South Texas Project Electric Generating Station P.O. Box 289 Wadsworth, Texas 77483

May 12, 2003  
NOC-AE-03001528  
10CFR50

South Texas Project  
Units 1 & 2  
Docket Nos. STN 50-498, STN 50-499  
Responses to NRC Questions Regarding  
Bottom Mounted Instrumentation Penetration Indications

STP BMI Generic J-Groove Configuration

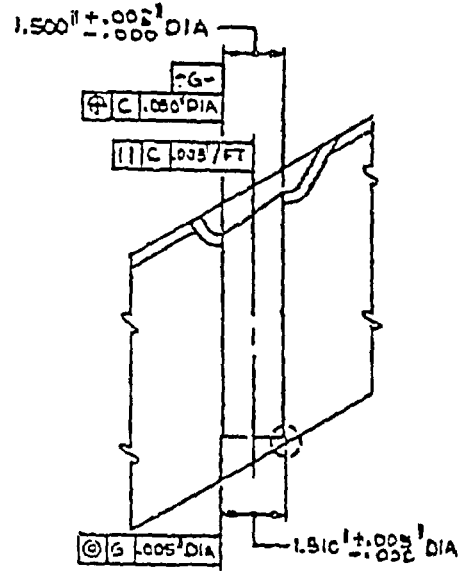
**Questions from May 1, 2003 Meeting:****11. Provide J-groove weld dimensions****Response:**

See attached diagrams.

STP BMI J-groove weld dimensions from Question 11.
